# CITY OF SHORELINE PLANNING COMMISSION SPECIAL MEETING

Commission Meeting Date: November 29, 2007

**AGENDA TITLE:** Continued Public Hearing on Planned Area 2 (Ridgecrest

Commercial Area)

Cc: Jessica Simulcik Smith Subject: Cascades Bingo Site

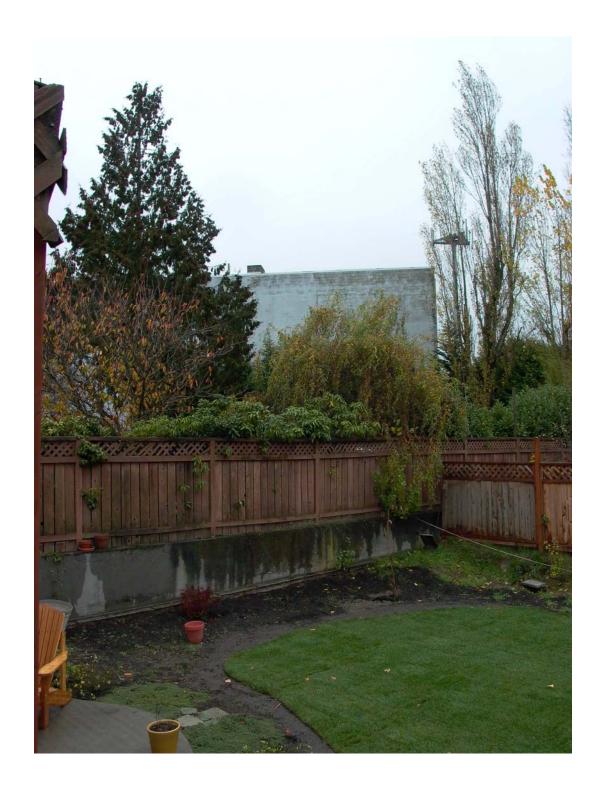
I will not be able to attend the planning commission meeting this evening, but I wanted to share the attached photos taken from my backyard to give the planning staff and any interested commissioners a sense of the current appearance of the site from my family's perspective. As you know from my written submission to the last planning commission meeting, I support the redevelopment of the site into a multi-use facility.

As you can see, the big blank wall dominates the view from our back yard, as well as our neighbors'. With this in mind, I am strongly supportive of a setback from the property line, a tree line or some other type of border to soften the appearance of the new development, and stepping back the upper floors of the new structure on the West side.
